Project: WEBSTER UNIVERSITY INTERDISCIPLINARY SCIENCE BUILDING
Customer: PARIC CORPORATION
Owner: WEBSTER UNIVERSITY
Location: WEBSTER GUOVES, MO 63119
Dwn: WT Date: 05/16/2016 Ckd: LJ Date: 05/17/2016
Job No. A16013 BAT: DWG#: AB1

SHOP DRAWING / SUBMITTAL REVIEW	
☐ NO EXCEPTION TAKEN	☒ EXCEPTIONS NOTED, RESUBMITTAL NOT REQUIRED
☐ REJECTED	
☐ REVIEWED FOR INFORMATION ONLY	☐ REVISE AND RESUBMIT AS NOTED
Checking is only for general conformance with the design concept of the project and general compliance with the information given in the Contract Documents. Any action shown is subject to the requirements of the plans and specifications. Contractor is responsible for: Dimensions which shall be confirmed and correlated at the job site, fabrication processes and techniques of the construction, coordination of his work with that of all other trades and the satisfactory performance of his work.	
DAVID MASON & ASSOCIATES, INC.	
REVIEW BY: JYW	DATE: 06/02/2016

RE: Anchor bolt shop drawings

TYPICAL BASE PLATE DETAIL. U.N.O.

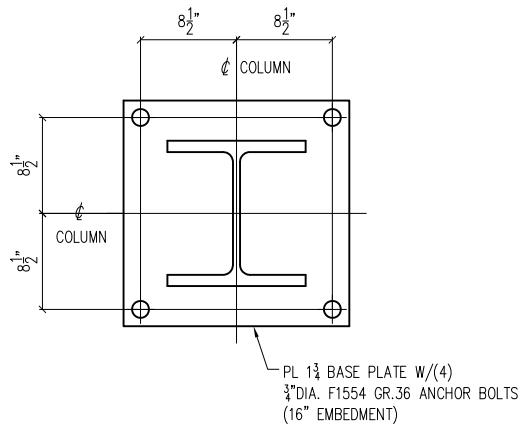
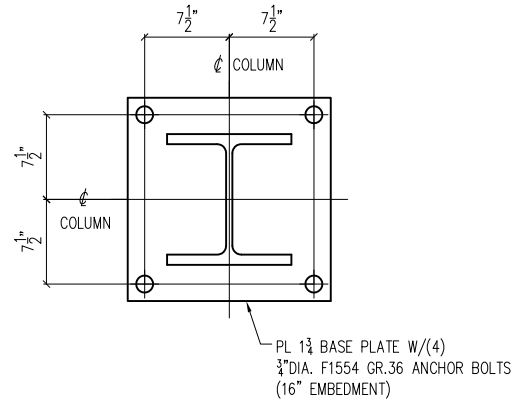
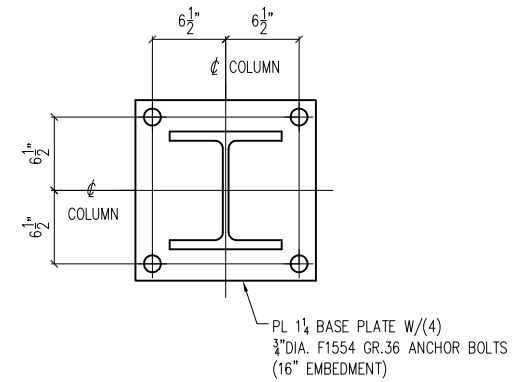
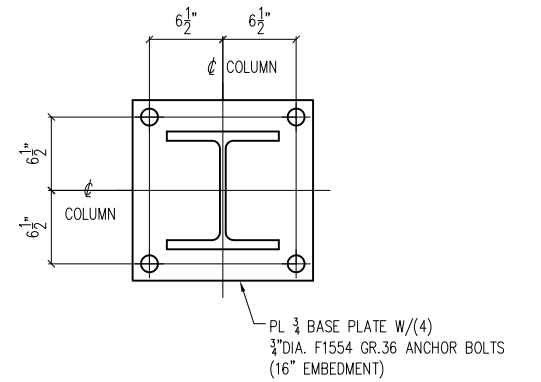
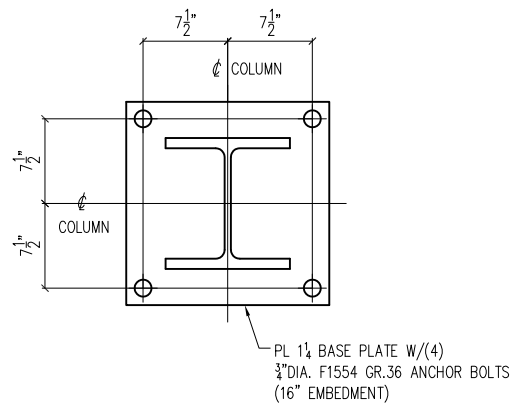
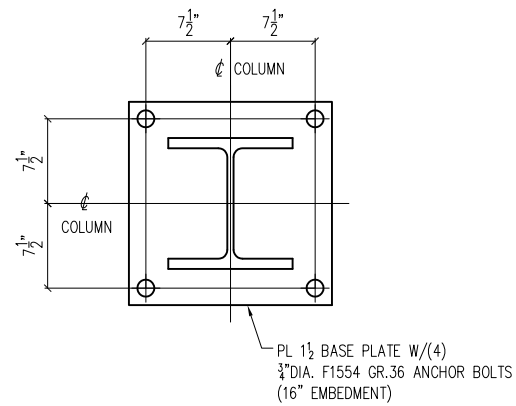
PROVIDE ANCHOR ROD
ASSEMBLY CALLOUTS.
VERIFY ALL ASSEMBLIES
THIS SHEET ARE "12A"

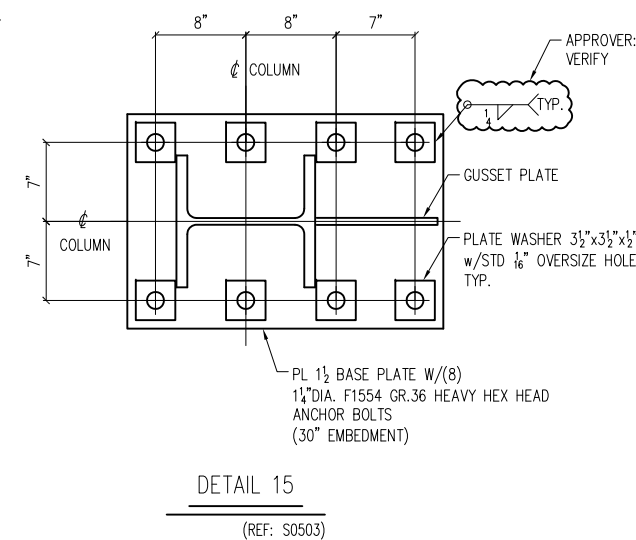
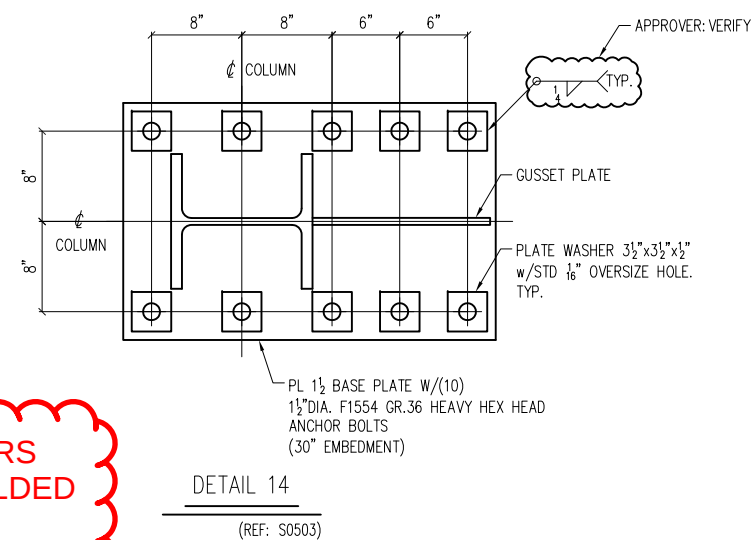
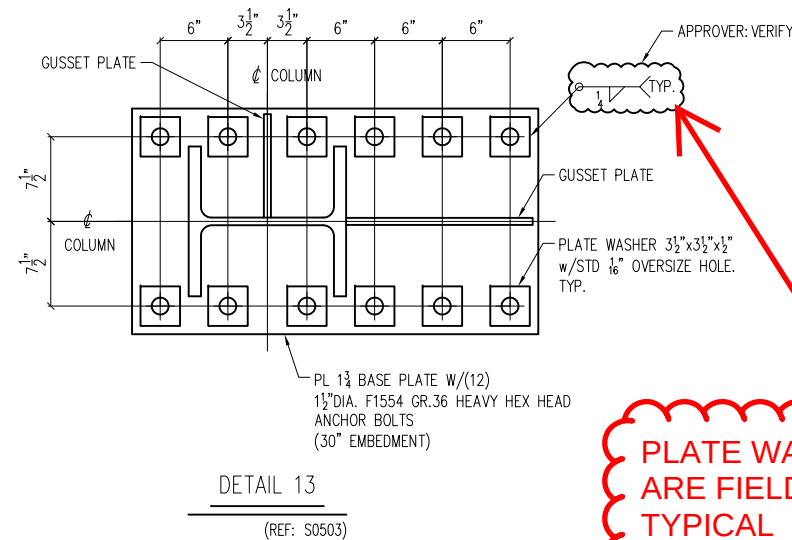
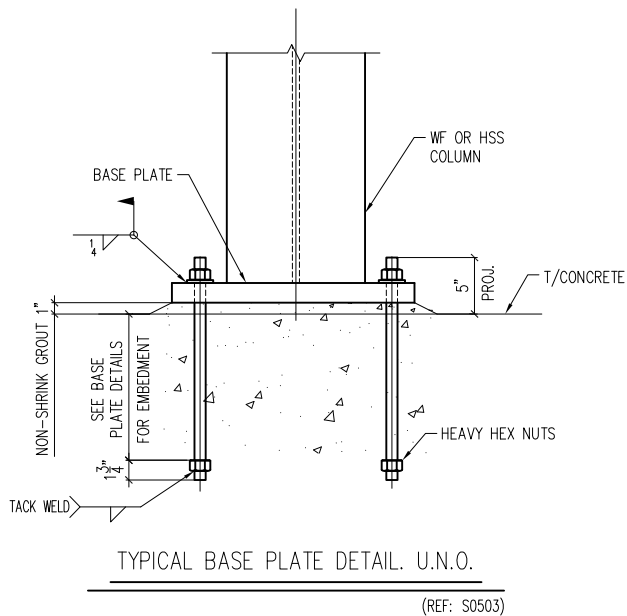
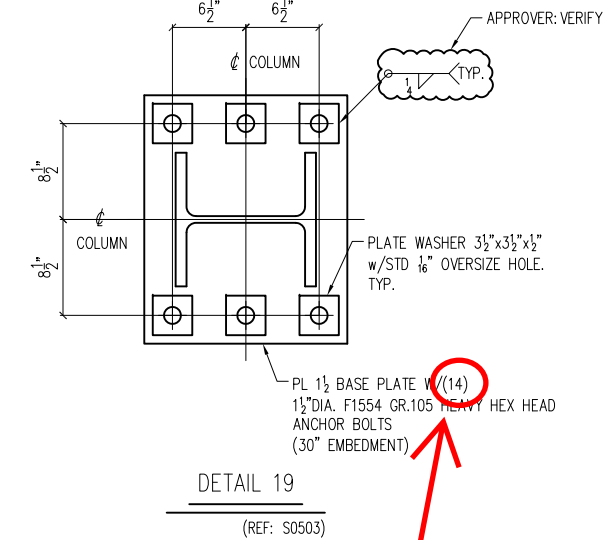
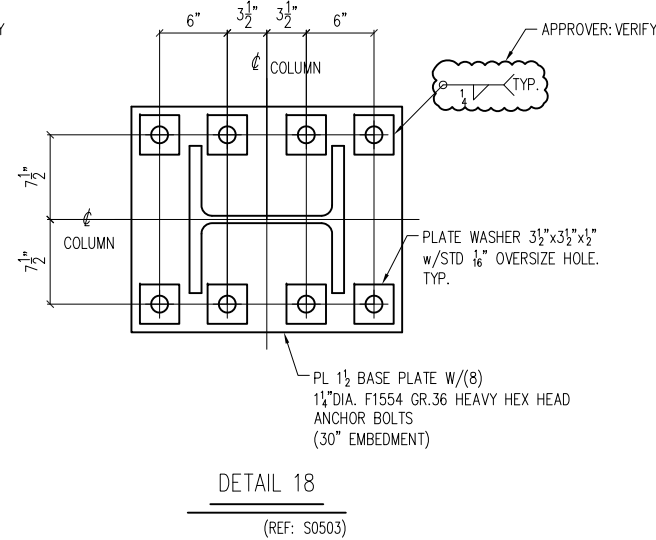
PLATE WASHERS ARE FIELD WELDED TYPICAL

PROVIDE ANCHOR ROD ASSEMBLY CALLOUTS FROM DWG #12
